### Gastineau Elementary School Renovation

Contract No. E11-137

**ADDENDUM NO.:** SEVEN

**DATE ADDENDUM ISSUED:** December 17, 2010

| SHEET #      | C1.3                              |

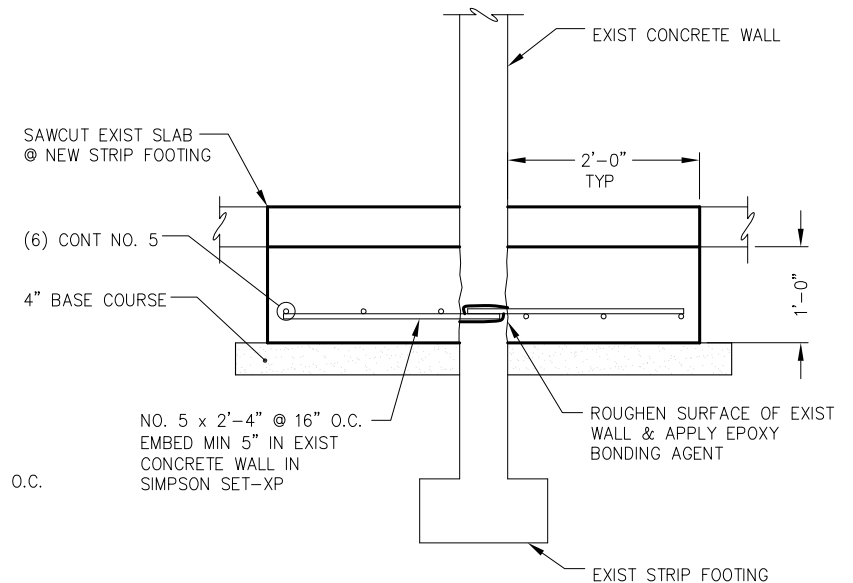
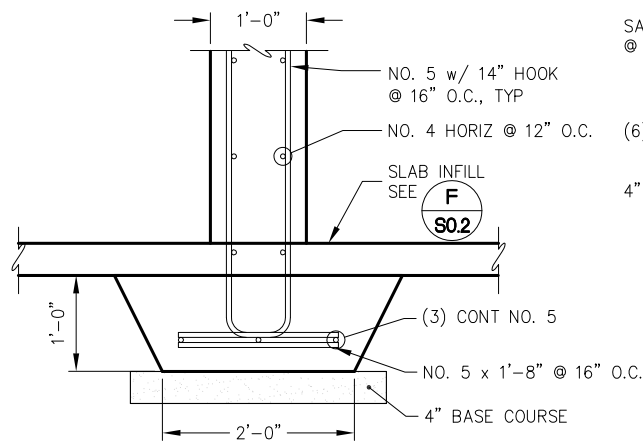
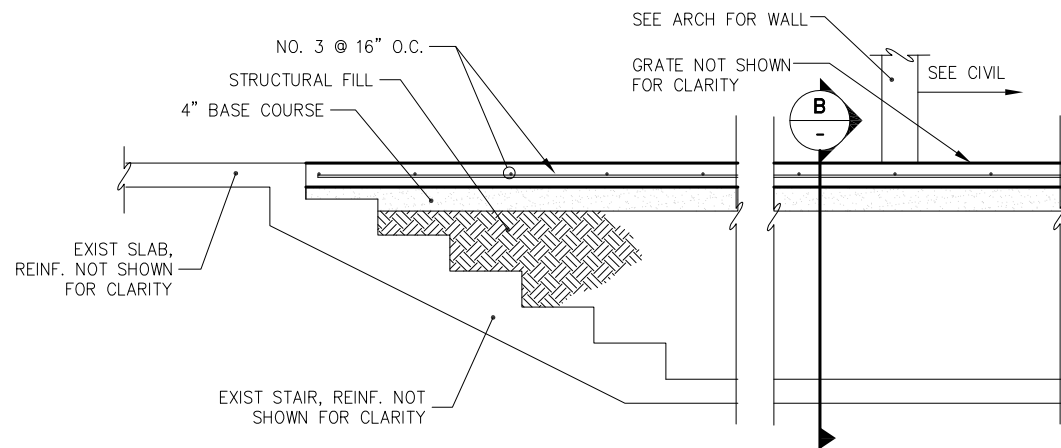
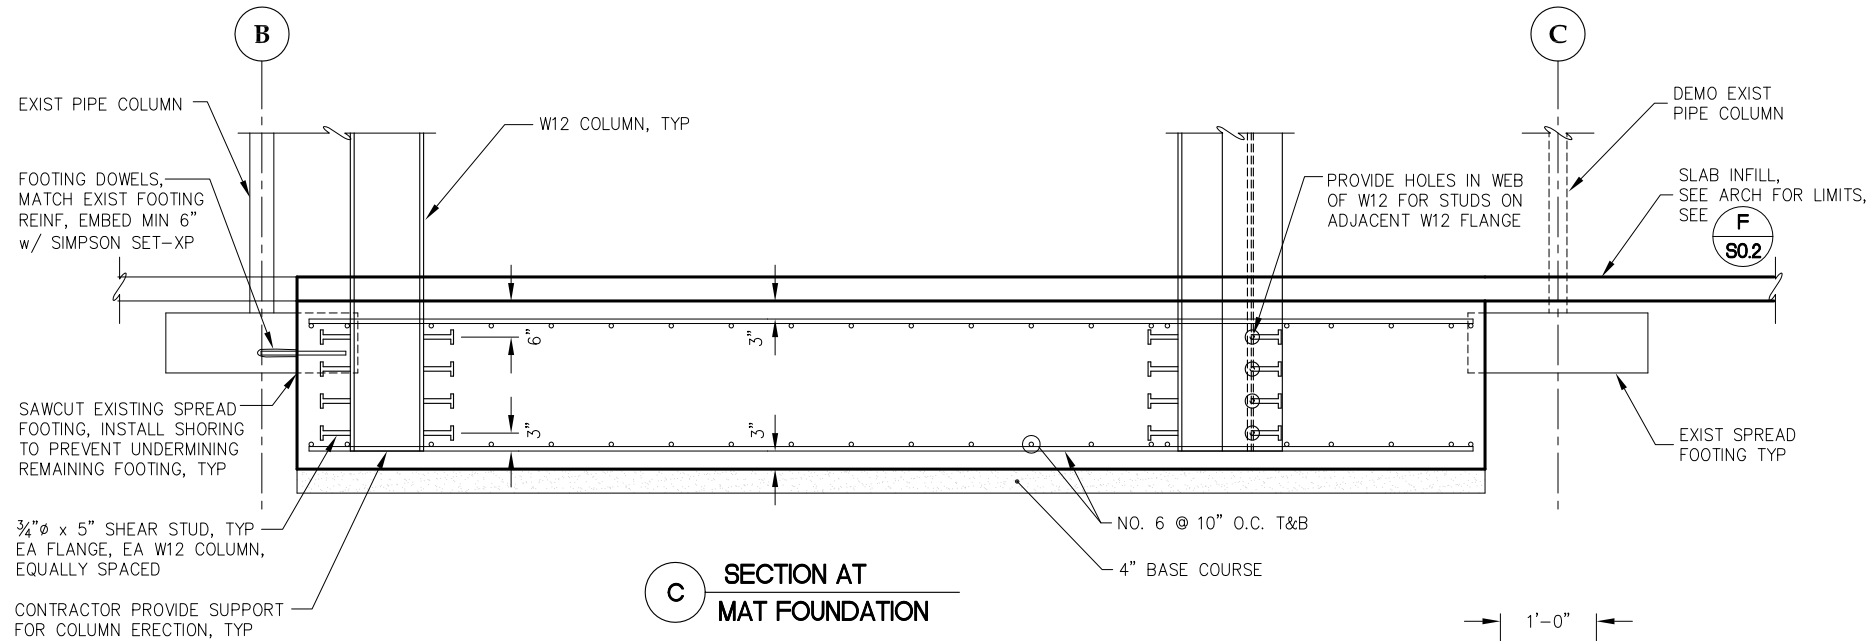
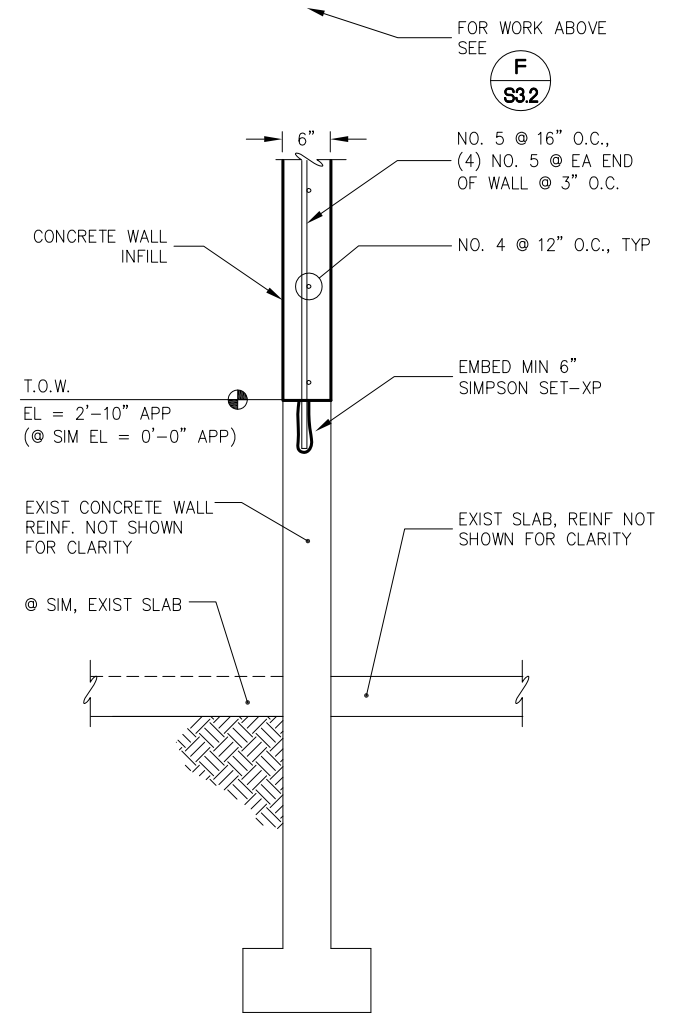
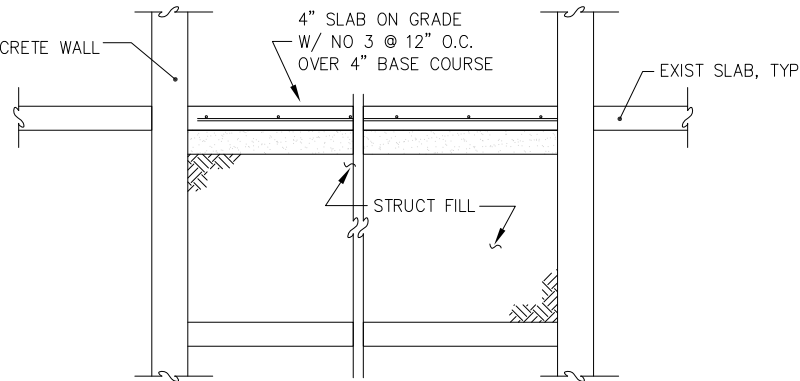
- Item No.        **Delete** drawing sheets C1.3, C1.9, C1.10 entirely and **replace** with the attached sheets labeled Addendum No. 7.
- Item No.        Sheet C1.8 – Driveway Plan & Profile Add. Alternate: **Modify** note “ Match exist edge ACP approx Sta 1+04” **to read:** “Match exist edge ACP approx Sta 1+04, saw cut and tack coat”.

**S2.2**

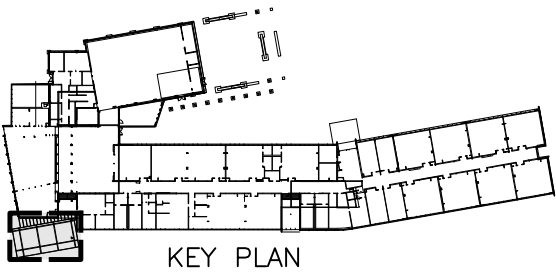
- Item No.        Sheet S1.2 – Demo Plan: Roof: Area A, Detail 1: **Change** bubble at note reading “For Concrete Wall Demo, See” to Detail 3 at S3.1.
- Item No.        Sheet S2.2 – Foundation Details, Detail A: **Delete** entire sheet and **replace** with the revised sheet S2.2, labeled Addendum No. 7.

**S4.1**

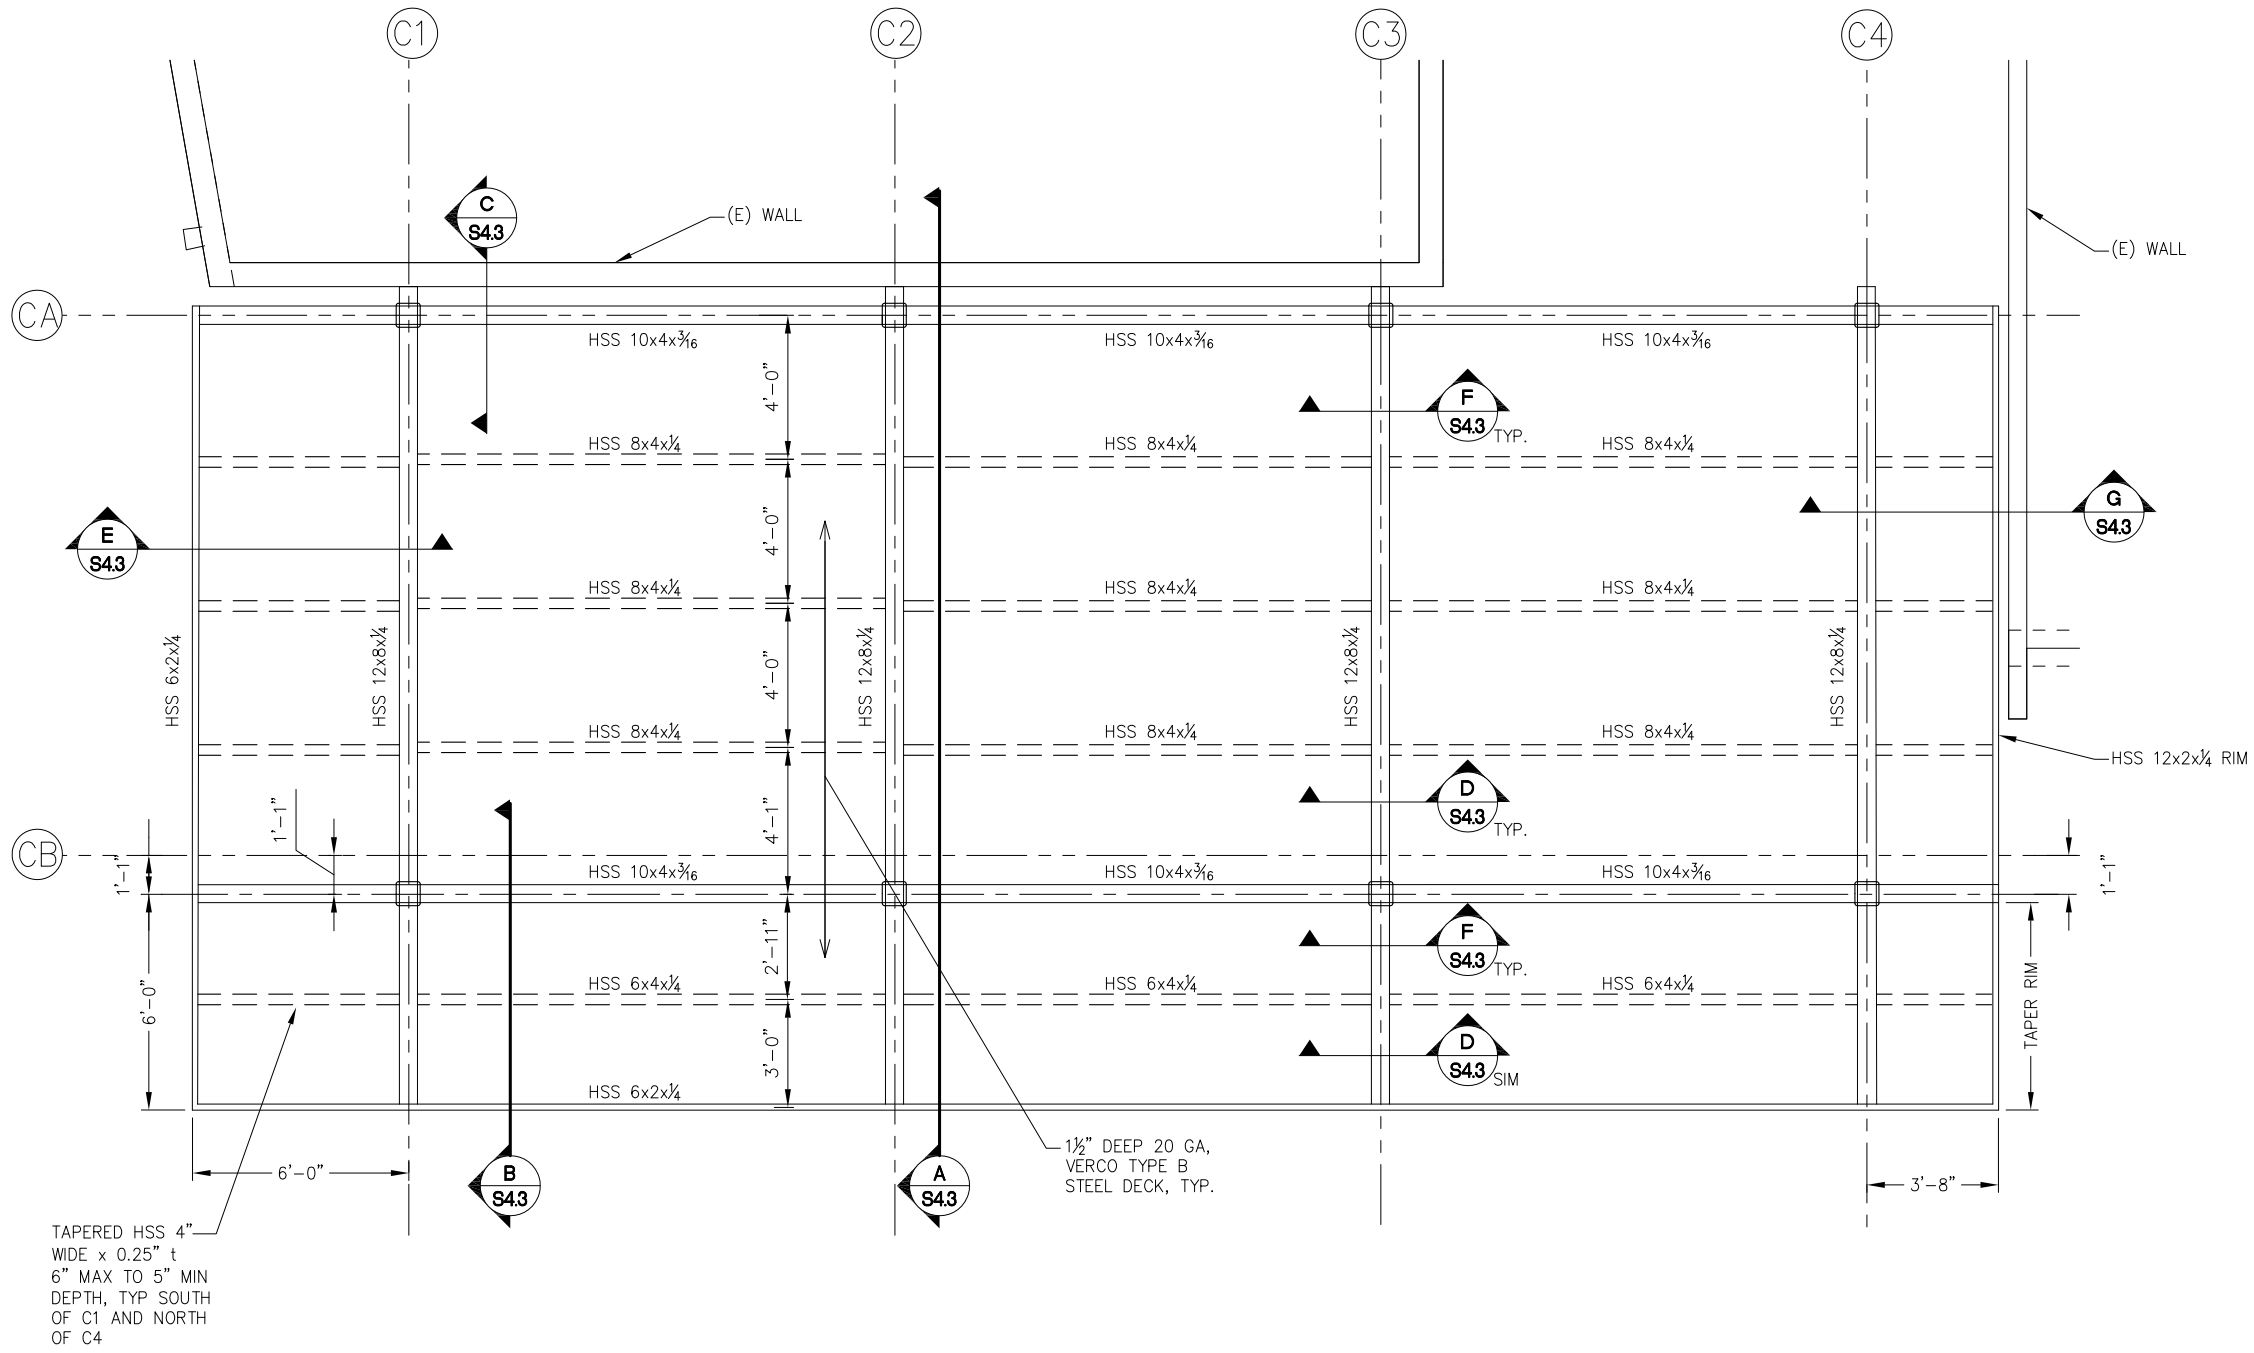
- Item No. Sheet S4.1 – Roof Framing Plan: Main Entry Canopy, Detail A. **Delete** entire sheet and **replace** with the revised sheet S4.1, labeled Addendum No. 7.
